TO: SWALE JOINT TRANSPORTATION BOARD

SUBJECT: Eden Village Proposed Bus Facility – Revised Report

Crossways Sittingbourne, Proposed Bus Gate

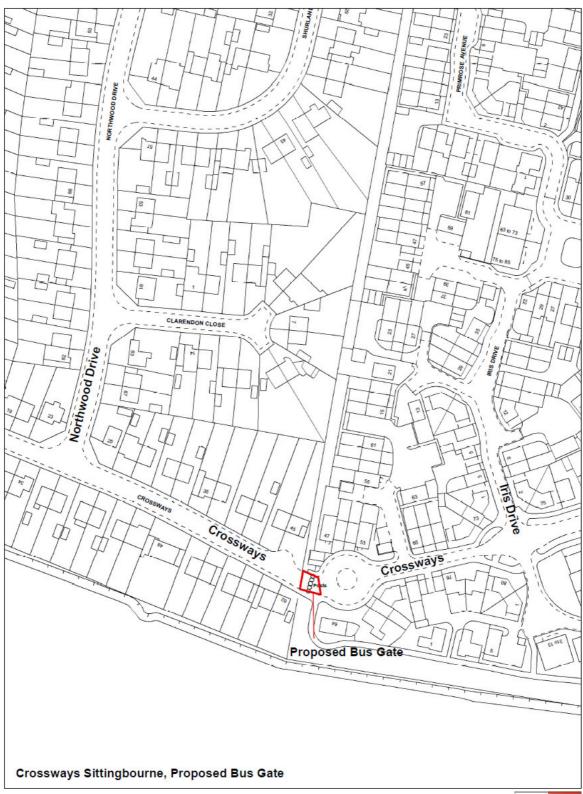
Kent Police have written in objection to the Order on the grounds that it will not be self enforcing and therefore ineffective and will leave the Police with the task of undertaking constant enforcement. The Police have also queried the suitability of the roads to act as a bus route. Kent Police request that the proposal is withdrawn until a physical bus gate or similar can be introduced.

The bus gate will not be wide enough for a bus.

The road was not designed with a bus route in mind and parked cars narrow its usable width. There is only a footway on one side of the road. Residents pulling off their drives or using the turning heads will be in serious danger of collision;

Two residents have since clarified that their objections are that no means of enforcement has been specified and that a lack of enforcement will create a potential short cut creating problems for residents in the houses adjacent to the bus gate.

The provision of the bus link and additional bus service was secured as part of the planning permission and the majority of the points raised in the objections would have been covered at that stage. Parking restrictions are not proposed as part of this scheme.

It is recommended that the bus only traffic order is progressed as advertised. The means of physical enforcement can be considered together with other TROs across the county that require physical means. The opportunity has been taken to reduce slightly the extent of the proposed restriction so that this does not include the access to any resident's drive.
